Re: Finance Docket No. 34658, The Alaska Railroad Corp. -- Petition For Exemption From 49 U.S.C. §10901 To Construct and Operate a Rail Line Between North Pole, Alaska and Delta Junction

Chapter 2

VERSION REDACTED FOR ARRC REVIEW AND COMMENT

Figure 2.5-2
Typical Cross Section of the Tanana River Bridge

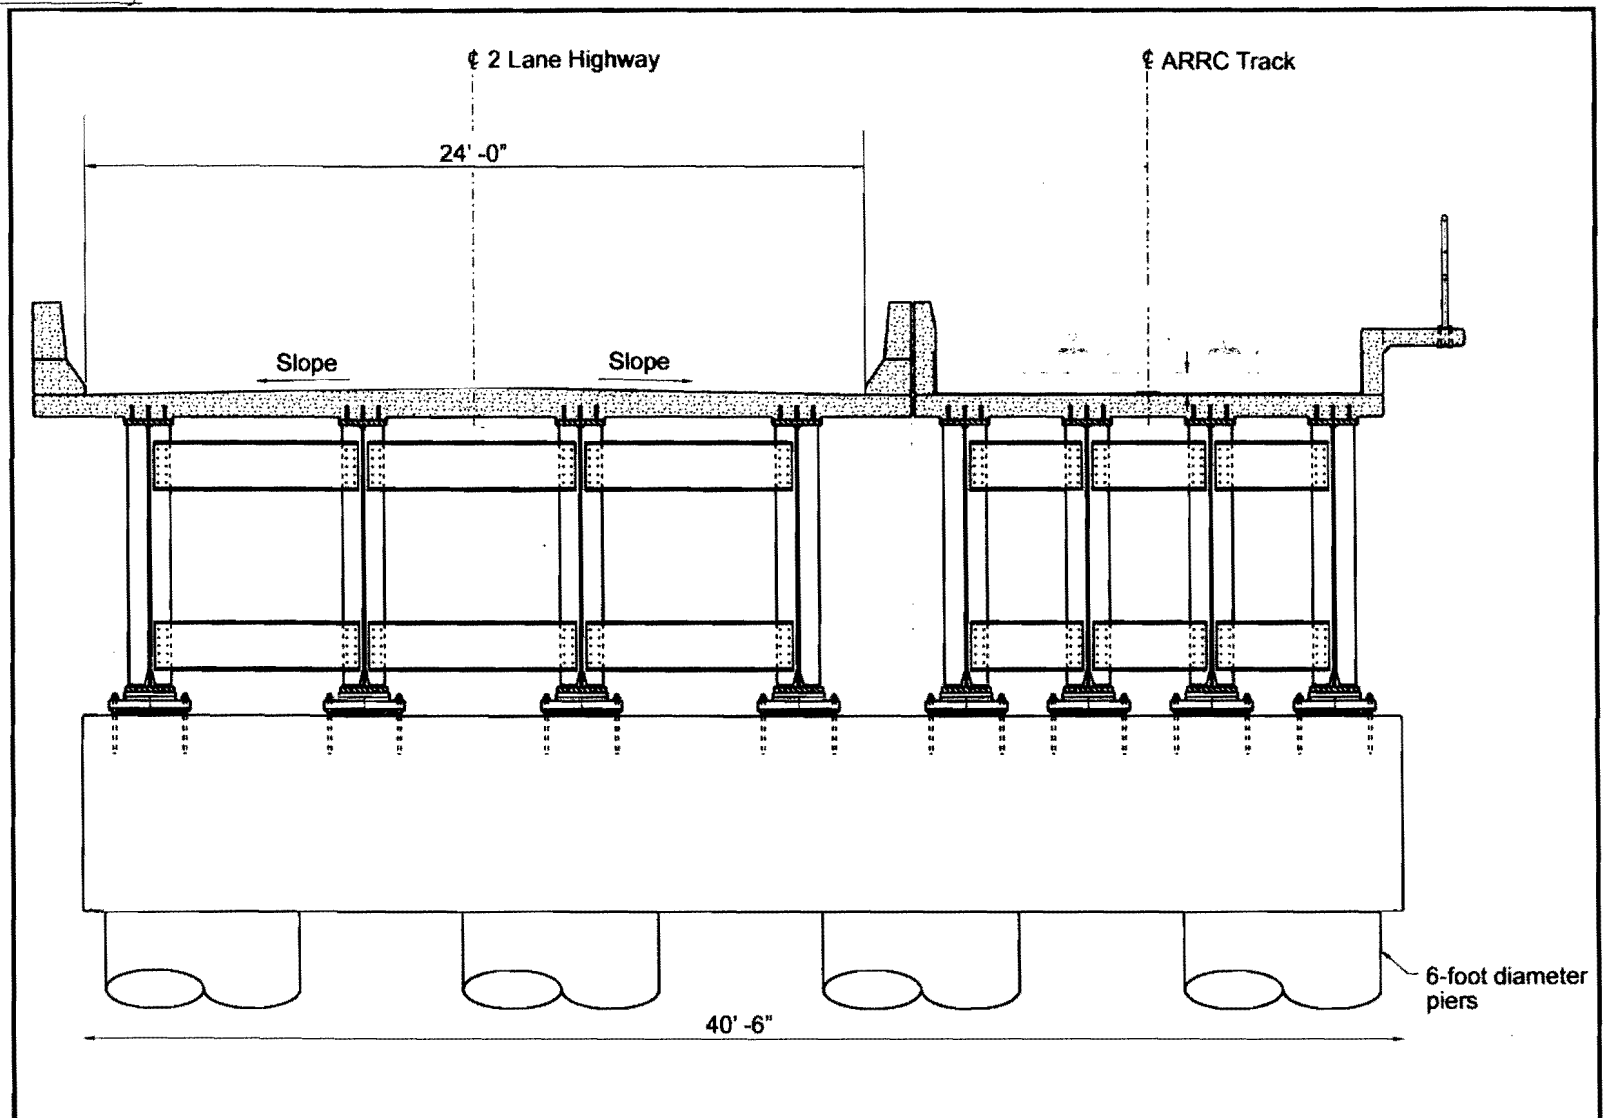
Regardless of location, the Tanana River Bridge would be a dual-modal bridge capable of providing both rail and vehicular access across the Tanana River. A 124-foot-wide road would be placed adjacent to coincident with the track and separated by concrete dividers (see Figures 2.5-2 and 2.5-3). The approach to the vehicle lane would loop under the bridge to avoid the need for an at-grade crossing of the rail line. Access to the Tanana River Bridge for the Salcha Alternative Segment 1 would be from modified existing private roads off the Old Richardson Highway (see Figure 2.5-6). Access to the Tanana River Bridge at the Salcha Alternative Segment 2 would be from the Old Valdez Trail. ARRC

1 Revised per VE study
